Car Stereo Service Bulletin

Model: XM-801

No. 133

Subject: Thermal Protector Trip Point

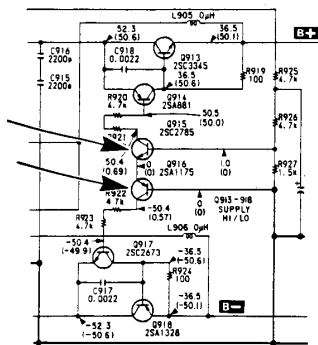
The thermal protector reacts prematurely during high-power playback (maximum power at no distortion).

Cause:
Q915 and Q916 are defective. In the stereo mode, the voltage applied to these transistors exceeds the rating voltage so the temperature of the power amplifier IC rapidly increases when the transistors prove defective.

Change Q915 and Q916.

| Ref. No. | Description | | Part Number |
|----------|-------------|----------|--------------|
| Q915 | 2SC2785 | 2SC2459 | 8-729-245-91 |
| Q916 | 2SA1175 | 2SA988-F | 8-729-108-14 |
